CHANGE ORDER FORM NO.: 2

Owner: City of Pipestone Owner's Project No.:
 Engineer: Bolton & Menk, Inc. Engineer's Project No.: 25X.139714
 Contractor: Duininck, Inc. Contractor's Project No.:
 Project: 2026 Street & Utility Improvements
 Contract Name: 2026 Street & Utility Improvements - 2nd Avenue SW
 Date Issued: October 9, 2026 Effective Date of Change Order: October 9, 2026

Neenah R-1976 8-inch Cleanout Casting

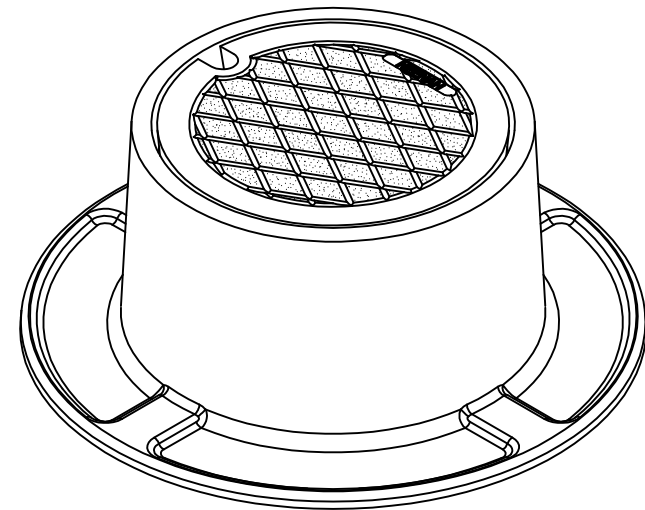
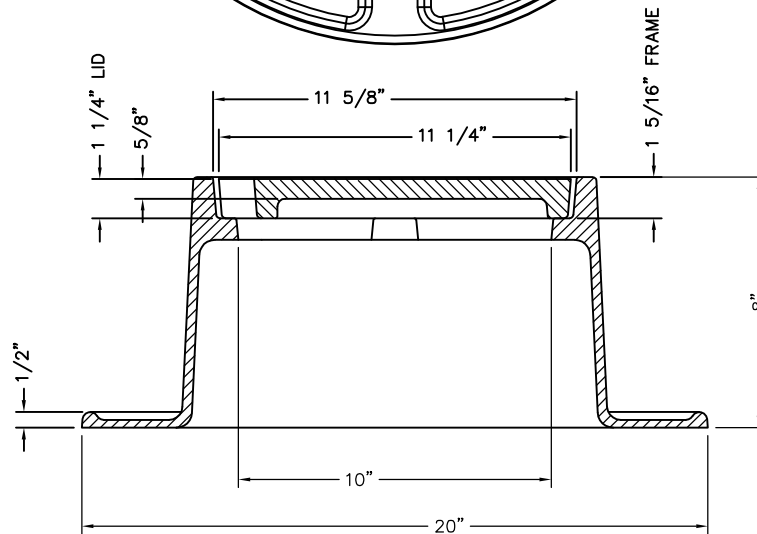
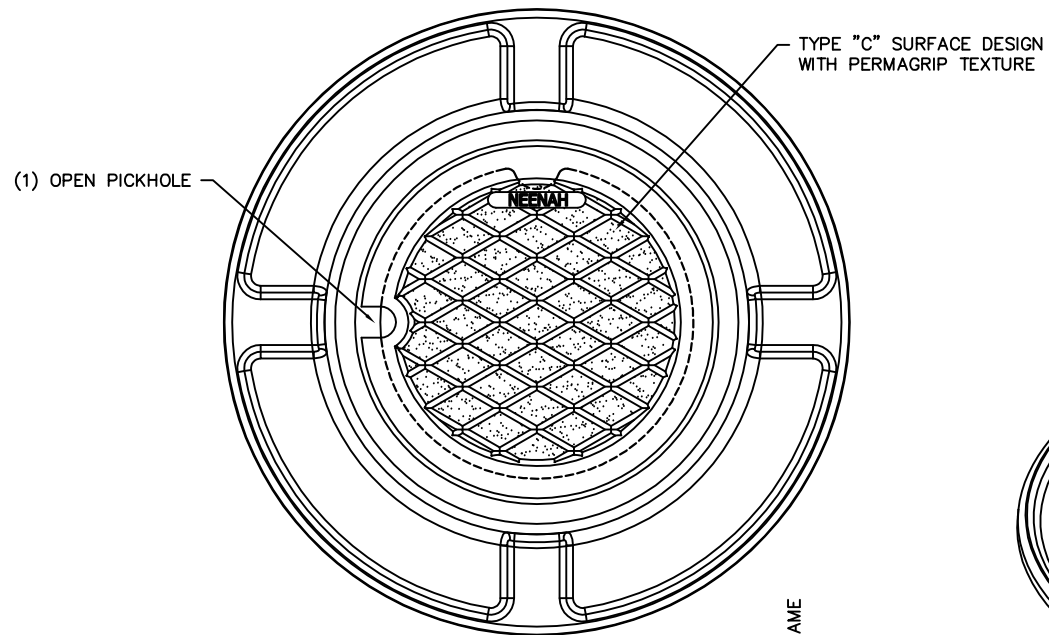
A casting will be installed over the sanitary service cleanouts that are within sidewalk and driveway areas. There will be a 2-week time extension due to rock excavation and some non-compliant private sewer and water services that were encountered during construction. Therefore, the Milestone 1 completion date will be extended to November 16, 2026.

Item No.	Description	Quantity	Unit	Unit Price	Total Amount
CO2-92	F & I 8" Cleanout Casting	14	Each	\$500.00	\$7,000.00
Total Change Order Amount and Estimated Contract Change =					\$7,000.00
